IMPORTANT SAFETY RECALL NOTICE

MORryde JEEP SPARE TIRE MOUNT JERRY CAN HOLDER

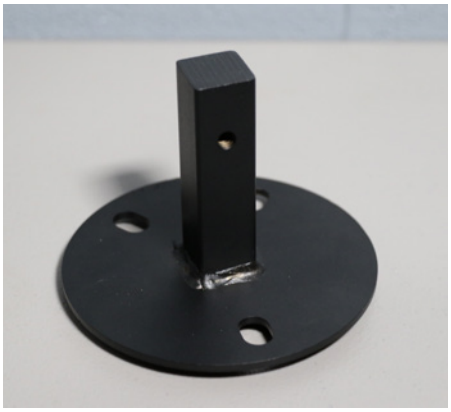
RECALLED PART

C-Channel

NEW PART

Solid Bar

REASON FOR RECALL: The C-channel that protrudes from the flat plate mounted between the spare tire and the vehicle spare tire mount may break free during transit causing damage and possible injury to other motorists.

INSPECTION: Inspect the underside of the stem sticking through the opening of the spare tire. This can be done by looking from below the Jerry Can Tray or by removing the Jerry Can Tray Assembly. If there is a nut welded to the inside of the C-channel, the part is affected by this recall. If the part is a solid bar, then no action is required.

Recalled part shown above as installed.

REMEDY: An upgraded solid bar mount will be provided at no charge for all affected parts. Discontinue use of the current part immediately to prevent damage or injury. Contact MORryde Customer Service for a replacement part and please be sure to note where the product was originally purchased.
